UNITED STATES
DEPARTMENT OF THE INTERIOR
BUREAU OF LAND MANAGEMENTFORM APPROVED
OMB NO. 1004-0135
Expires: July 31, 2010**SUNDRY NOTICES AND REPORTS ON WELLS**
*Do not use this form for proposals to drill or to re-enter an abandoned well. Use form 3160-3 (APD) for such proposals.***SUBMIT IN TRIPLICATE - Other instructions on reverse side.**

CHEVRON MIDCONTINENT RESPECTFULLY REQUESTS A REVISED NOI WITH A NEW PLUGGING PROCEDURE AS APPROVED BY JACK SAVAGE, FEBRUARY 29, 2016, IN NOI - ID 332209.

Rincon Unit #212
Rio Arriba County, New Mexico
PROPOSED Wellbore Schematic
Free Flowing Well, Currently SI

Re: Permanent Abandonment
Well: Rincon Unit 212

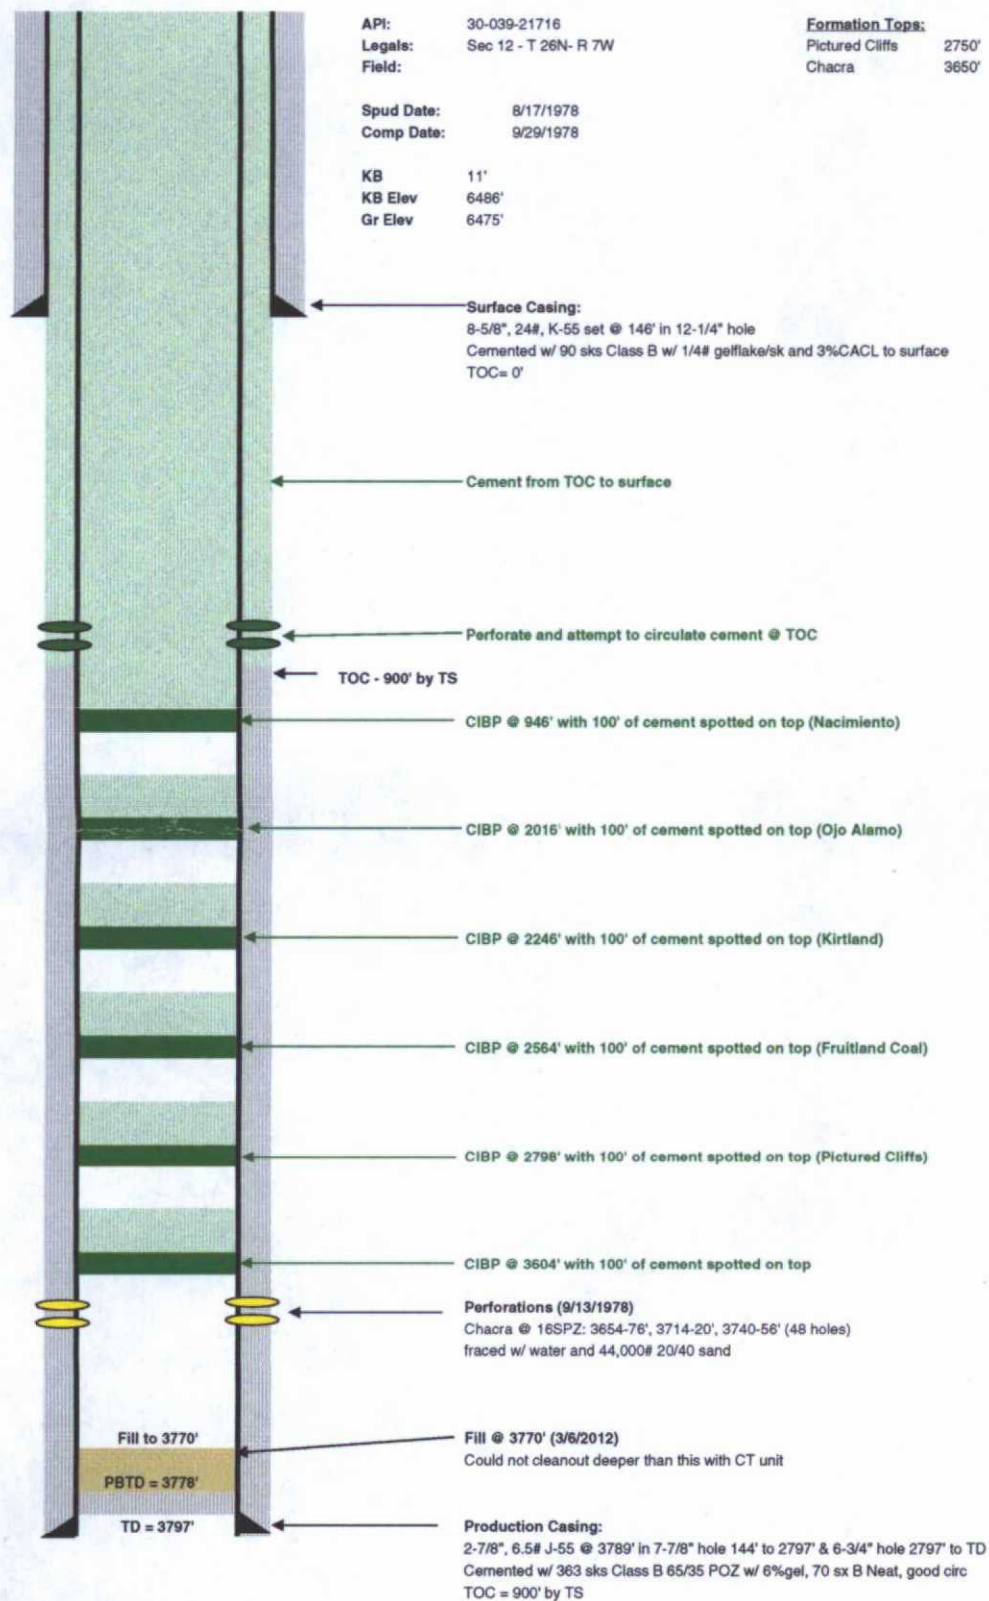
RIG UP WIRELINE

SET CIBP #1 @ 3604' AND DUMP BAIL 100' OF CEMENT ON TOP

SET CIBP #2 @ 2798' AND DUMP BAIL 100' OF CEMENT ON TOP

SET CIBP #3 @ 2564' AND DUMP BAIL 100' OF CEMENT ON TOP

SET CIBP #4 @ 2246' AND DUMP BAIL 100' PF CEMENT ON TOP

SET CIBP #5 @ 2016' AND DUMP BAIL 100' OF CEMENT ON TOP

SET CIBP #6 @ 946' AND DUMP BAIL 100' OF CEMENT ON TOP

PERFORATE 2-7/8" CASING @ TOC FROM CBL (TOC ~ 900' FROM TEMPERATURE SURVEY)

TIE ONTO 2-7/8" CASING, ATTEMPT TO ESTABLISH CIRCULATION AND CIRCULATE CEMENT TO SURFACE

1. Plugging operations authorized are subject to the attached "General Requirements for Permanent Abandonment of Wells on Federal and Indian Lease."
2. Farmington Office is to be notified at least 24 hours before the plugging operations commence (505) 564-7750.
3. The following modifications to your plugging program are to be made:
 - a) Bring the top of Plug #4 to 1916 ft. to cover the Kirtland and Ojo Alamo top. BLM picks top of Kirtland at 2196 ft. BLM picks top of Ojo Alamo at 1966 ft. Adjust cement volume accordingly.
